SUBDIVISION REVIEW SHEET (VARIANCE ONLY)**CASE NO.:** C8-2015-0279.0A**P.C. DATE:** November 8, 2016**SUBDIVISION NAME:** Marcy Hill Resubdivision**AREA:** .851 acre**LOT(S):** 4**OWNER/APPLICANT:** Jaomi Brasher**AGENT:** Michael Friedman**ADDRESS OF SUBDIVISION:** 1104 MARCY ST**GRIDS:** G18**COUNTY:** Travis**WATERSHED:** W Bouldin Creek**JURISDICTION:** Full Purpose**EXISTING ZONING:** SF-3**DISTRICT:** 5**NEIGHBORHOOD PLAN:** S Manchaca**PROPOSED LAND USE:** Single family**ADMINISTRATIVE WAIVERS:** None

RESUBDIVISION OF
LOTS 4 AND 5 BLOCK A
BANISTER ACRES
SECTION 2

SUBJECT: C8-2015-0279.0A Marcy Hill Subdivision, (a Resubdivision of Lots 4 and 5, Block A, Bannister Acres Subdivision) Flag Lot variance request

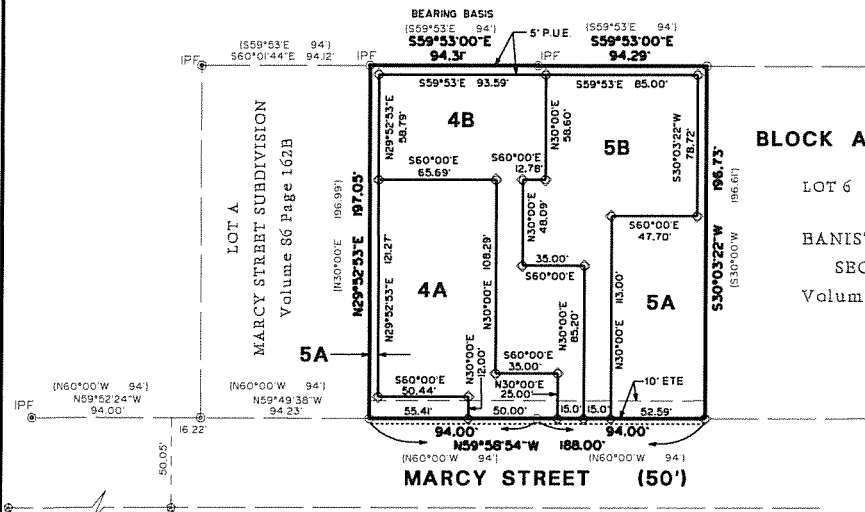
The applicant for the above referenced subdivision application has requested a variance from Section 25-4-175(A)(2) of the Land Development Code to utilize a flag lot design for a resubdivision creating 2 single family residential lots. In reviewing the variance request, staff evaluated the request based upon the criteria below, (see criteria and staff response):

The applicant has met with Austin Fire Department review staff and AFD staff has determined that the flag lot configuration proposed will not inhibit accessibility for emergency responders.

The applicant has provided a driveway and utility plan to reviewers for the City of Austin Water and Wastewater review and Austin Energy Departments. The reviewers have determined after review of the utility/driveway plan that there is adequate room to provide utility service to both lots and utilities will not cross the proposed new lot lines.

The applicant has provided a tree survey to arborist staff with the City of Austin and the arborist have no objections or further recommendations.

There is an existing flag lot development in the immediate vicinity, (two lots west of this lot, on the same side of Marcy Street). The entire area is zoned SF-3-NP which is the appropriate zoning for the proposed use.

The applicant has determined that there are no existing private deed restrictions that are applicable to this property.

Based upon review of these criteria, staff **recommends** the variance request to develop a flag lot as a part of this resubdivision request.
